PERMIT

P 37016
A REPAIR

SEWAGE DISPOSAL SYSTEM

PROPERTY OWNER STEPHANIE Nagurny STRAB
ADDRESS 11501 John Hopkins Road

37016
A Repair

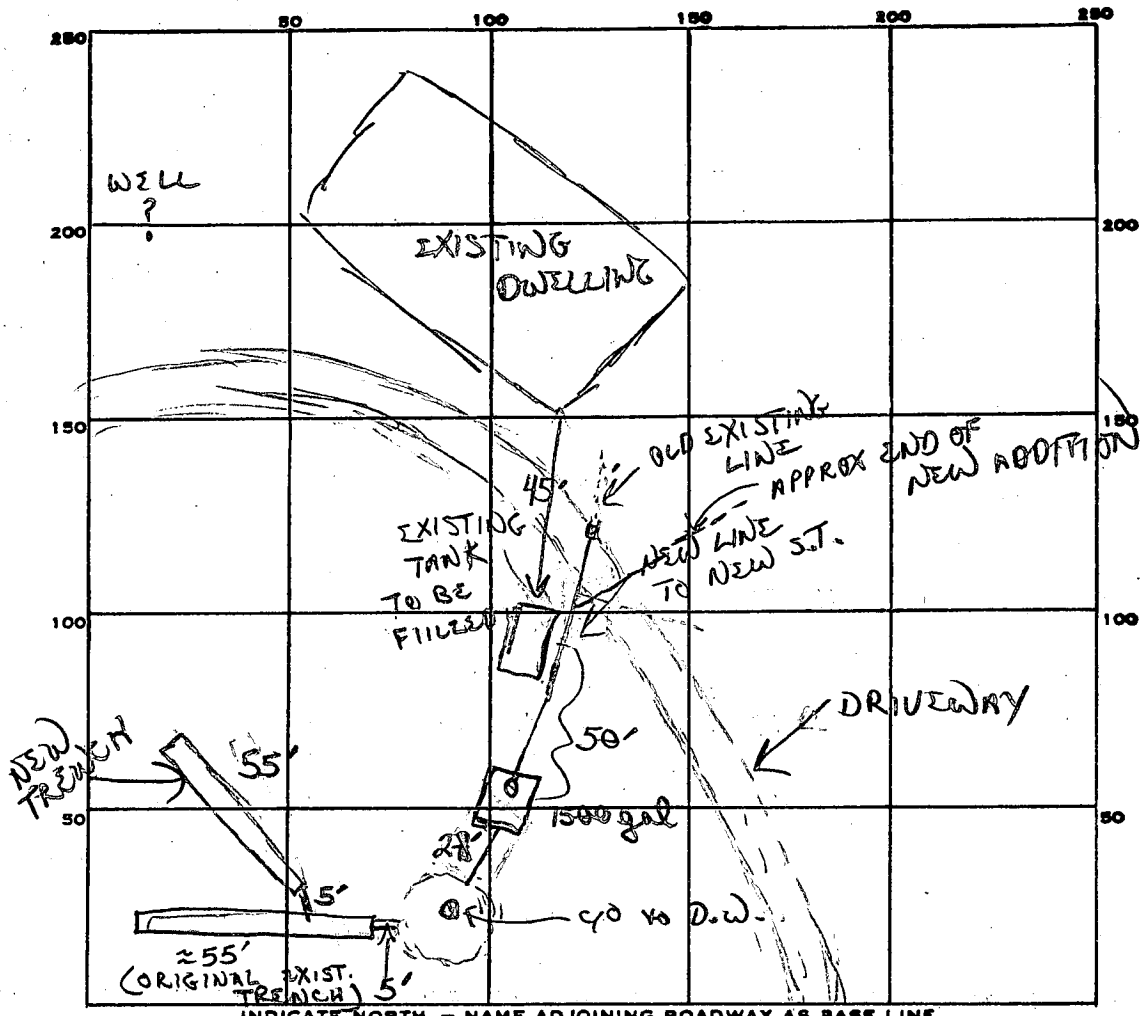
Replace 1000 gal tank w/ 1500 gal (1000 ^{to be} filled in + left)
add extra trench off existing trench + d.w. to get ↑ #
"Y" off existing trench / D.W. to get new trench. soils silty/sandy
near lawn

REMARKS OK to fill in 1000 gal existing tank + replace w/ 1500 gal
OK to add new trench off existing DW/trench to accommodate
↑ # of bedrooms
OK to add stone pipe paper to trench, OK to cover trench
& all work
